TOWN OF ERIE
BOARD OF TRUSTEE AGENDA ITEM
Board Meeting Date: February 14, 2017

SUBJECT:	GENERAL BUSINESS:
	A Sketch Plan Review of Parkdale (Erie Gateway South)
CODE REVIEW:	Erie Municipal Code, Title 10
PURPOSE:	A Sketch Plan represents a generalized land use plan and layout for the area proposed to be included within a subdivision. A Sketch Plan application is required to allow for an early, informal evaluation of a proposed subdivision before detailed planning and engineering work has occurred.
DEPARTMENT:	Community Development
PRESENTER:	Todd Bjerkaas PLA, Senior Planner

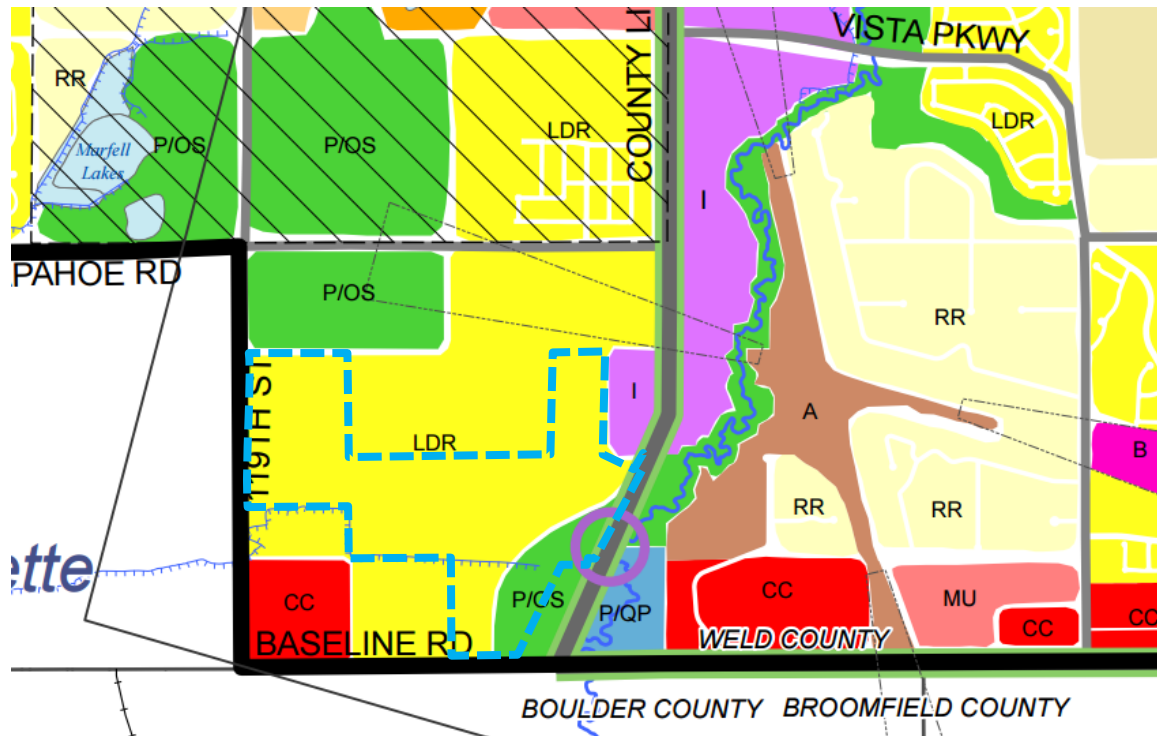
The Sketch Plan application proposes a new gateway into the Town of Erie through construction of a new entrance from State Highway 7, a realignment of County Line Road as a landscaped parkway, and the development of residential units and landscape areas on both sides of this new north-south arterial. A collector road heading east from the arterial provides access to the Messersmith-Boehle Open Space properties along Coal Creek and the original County Line Road alignment. A single access point into the subdivision is located off N. 119th Street. The

plan also provides for several road stubs into adjacent properties that could be developed in the future.

The development incorporates multiple single-family detached lot types described by the applicant as ranging from larger Manor Home and Country Home lots down to Village Home and Patio Home lots. Alley-loaded Paired Homes, mostly facing interior common green spaces, are proposed in the northeast portion of the subdivision adjacent to Tri-County Storage.

Wetlands exist at the southeast corner of the site, and the applicant is preserving the wetlands as dedicated open space. This open space area is in compliance with the Town's Comprehensive Plan Land Use Plan Map which designates the wetlands as Parks/Public Open Space. An east-west Spine Trail alignment is proposed from the Great Bark Dog Park on N. 119th Street in Lafayette east through an open space corridor, through an underpass beneath the new County Line Road alignment, along the north edge of the wetlands, across the old County Line Road alignment, and connects into the existing Coal Creek Trail.

- *Neighborhood Park:* The development generates a requirement for 5.57 acres of Neighborhood Park. As this acreage falls short of the minimum 7 acre Neighborhood Park requirement, the developer will be required to make payment of the Neighborhood Park Land and Development Construction Cost Fee at Final Plan.

- *Pocket Park:* A total of 0.93 acres of pocket park are required. Based on the layout of the subdivision and compliance with the UDC's location requirements, at least four pocket parks, as shown in the Sketch Plan, are required and would exceed the 0.93 acre requirement.

- *Open Space:* The open space dedication requirement at Parkdale's proposed unit count is 31.59 acres. The Sketch Plan represents an open space dedication in the amount of 40.92 acres. Further analysis shall occur during Preliminary Plat to insure that all public open space areas identified for dedication are eligible for credit.
